# SERVICE BULLETIN

## SB-08-174 Rev. A

### Haldex Life Seal Long Stroke Brake Chamber - Recall

#### **UTM Reference: #388011**

# Life Seal® Identification

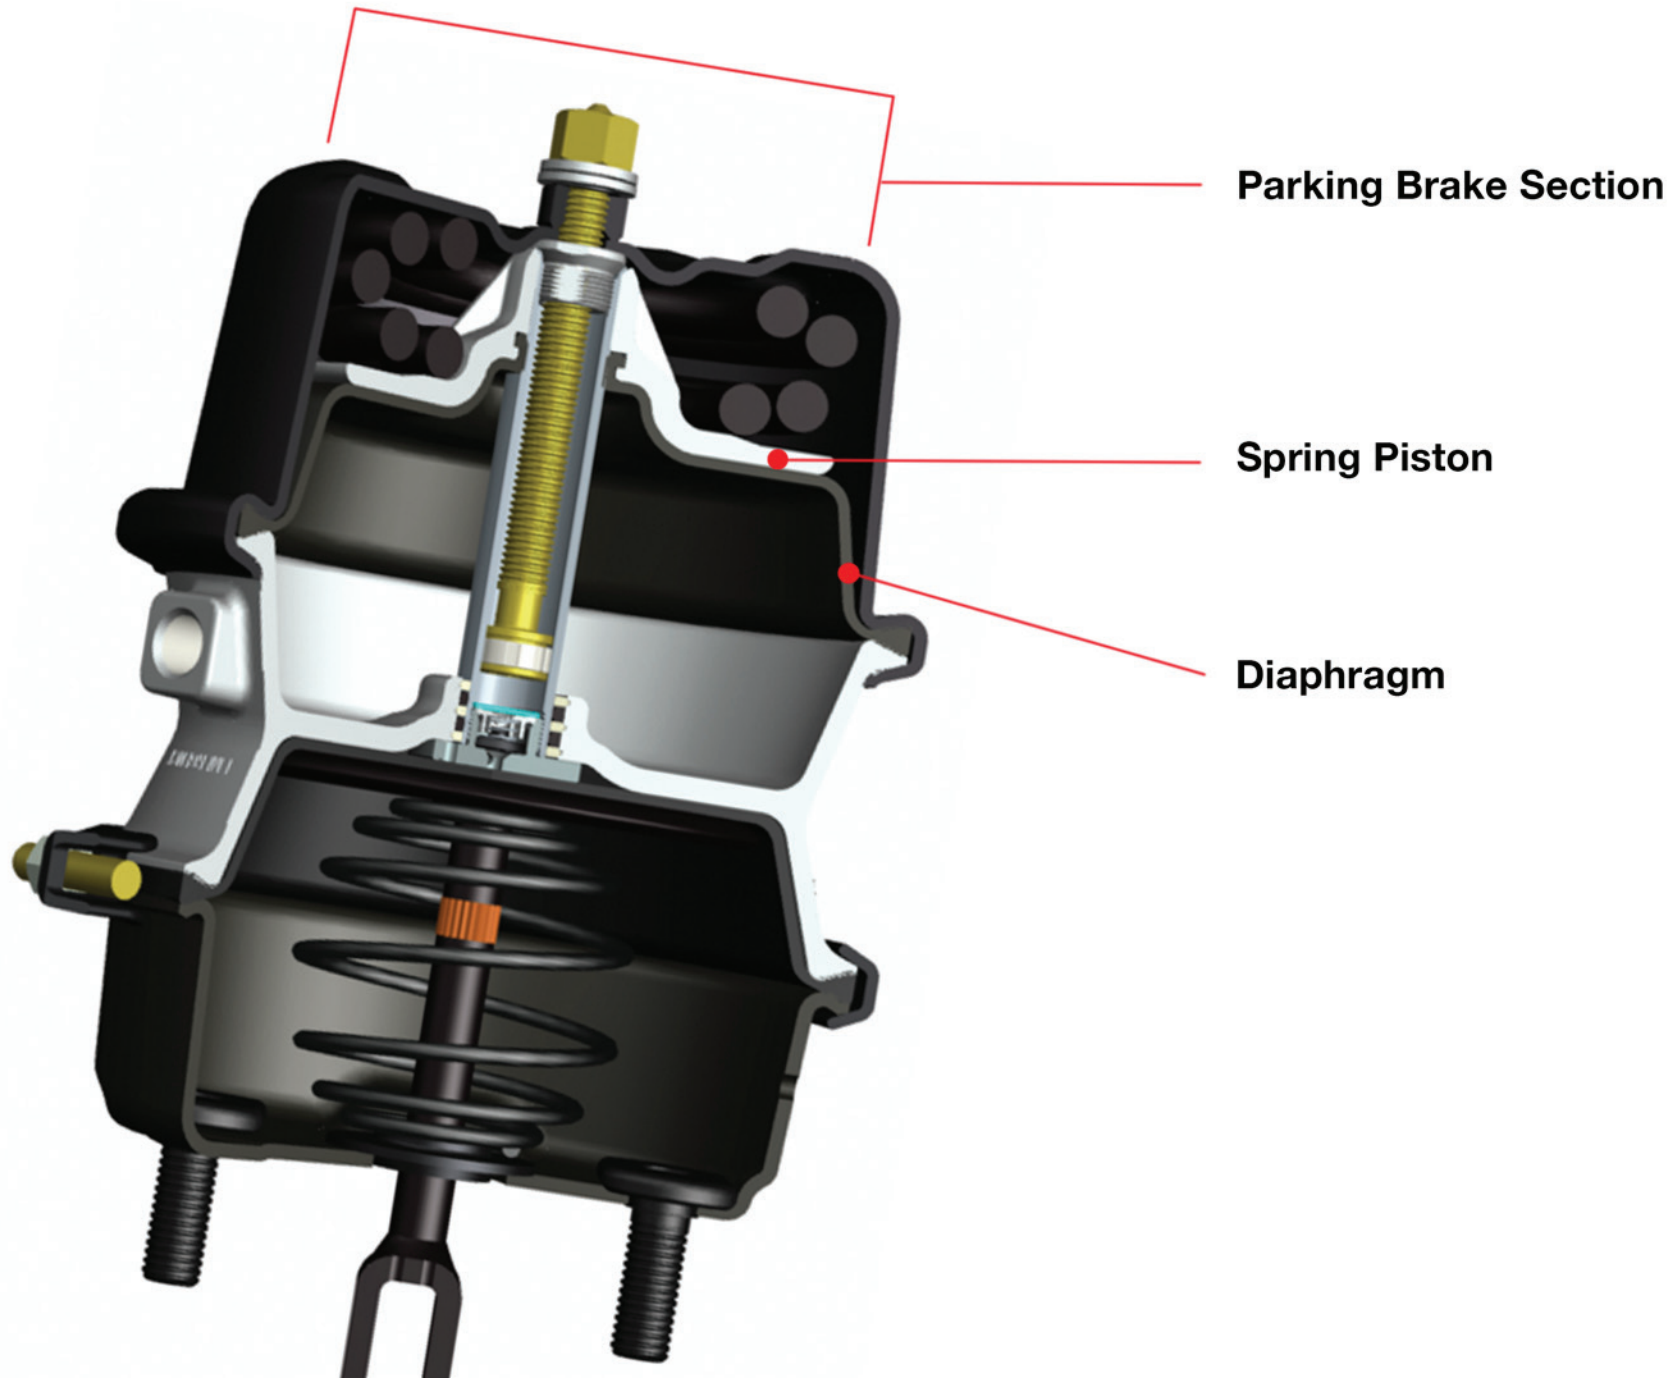
This specification defines a seven character alpha numeric date code. The first three digits indicate the Julian calendar day of the year. The fourth alpha character indicates the production shift. The fifth and sixth digits indicate the last two numbers of the year of manufacture. The last alpha character indicates the manufacturing location.

Example: Assembly built on first shift in Apodaca, Mexico on October 29, 2013

Suspect Date Range:  
January 9, 2014 - October 28, 2014

1. Identify trailer VIN per the list provided by Utility Field Service
2. Call Haldex for the necessary supply of Gold Seal 3030 Long Stroke chambers
3. Replace all Haldex Life Seal 3030 Long Stroke chambers as pertaining to the recall
4. Replace with Haldex Gold Seal 3030 Long Stroke chambers
  - ❖ Gold Seal 3030 long stroke will carry a 6 year warranty through Haldex
5. Fill out attached Gold Seal Replacement Form and return to Haldex
6. Ship take-off Haldex Life Seal 3030 Long Stroke chambers per the following instructions:
